A 2000-1 Addison Circle  
Roundabout Shopdrawings for Relocation of  
Waterline - 1996

RE: Addison Circle Phase I Public Infrastructure  
Roundabout Waterline Relocation  
HZI Job No. 01-1822-12

BID NUMBER: 96-28 / CHANGE ORDER NO. 5

RE: Final Plat/Addison Circle Phase I  
HZI Project No. 01-1932-01

**FINAL PLAT**  
**ADDITION CIRCLE PHASE I**  
 11.088 ACRES IN THREE BLOCKS  
 SITUATED IN THE  
 TOWN OF ADDISON  
 DALLAS COUNTY, TEXAS

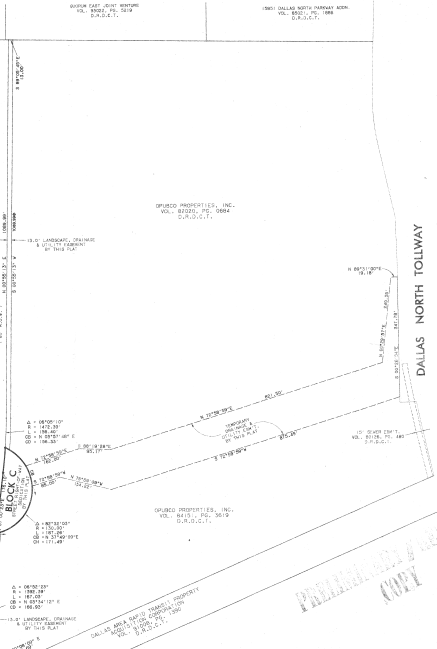
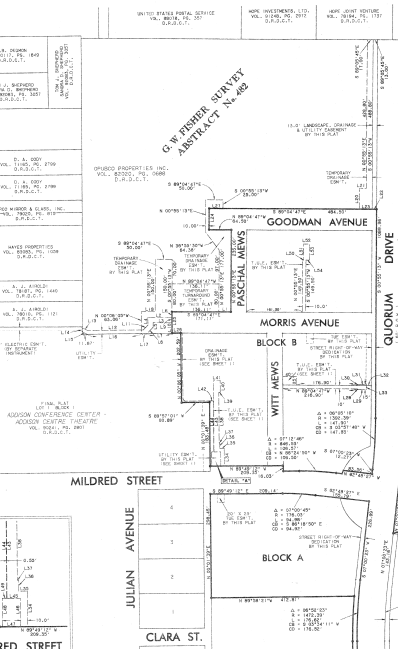
1. *The following note shall be added to sheet one:*

*The use of the "private utility easements" shown on this plat are subject to the terms and conditions set forth in the street license/rental agreement between Columbus Realty Trust and the Town of Addison recorded in Dallas County Records Volume \_\_\_\_\_ Page \_\_\_\_\_.*

2. *Easements necessary for Southwestern Bell, Lone Star Gas, Herron Cable, TCI Cable, etc. are not indicated on the plat. Location, with a "sign-off" by all public utilities for easements and cross sections in rights-of way shall be included.*

3. *The last paragraph on page 3, shall be deleted. It reads:*  
*All parcels conveyed or dedicated to the Town of Addison by virtue of this plat are subject to the provisions of that certain "RESERVATION AGREEMENT" between the Town of Addison, Gaylord Properties, Inc. and Addison Circle One, Ltd. dated \_\_\_\_\_, 1996 and recorded in Volume \_\_\_\_\_ Page \_\_\_\_\_ of the deed restrictions of Dallas County.*

There are no longer any private utility easements on the plat, therefore the note referencing them does not apply and should not be added to the plat.

Huitt-Zollars has contacted and received "sign-offs" from Southwestern Bell, TU Electric and Lone Star Gas. As discussed with Mr. Baumgartner, we received no response from TCI Cablevision. Mr. Baumgartner stated that we had met the obligation of utility "sign-offs" with the responses received and the attempts with TCI. (See attached letters)

It is Mr. McWilliams belief that this paragraph should remain on the plat but that it should read:

All street right-of ways dedicated to the Town of Addison by virtue of this plat are subject to the provisions of that certain "RESERVATION AGREEMENT" between the Town of Addison, Gaylord Properties, Inc. and Addison Circle One, Ltd. dated \_\_\_\_\_, 1996 and recorded in Volume \_\_\_\_\_ Page \_\_\_\_\_ of the Deed Records of Dallas County, Texas.
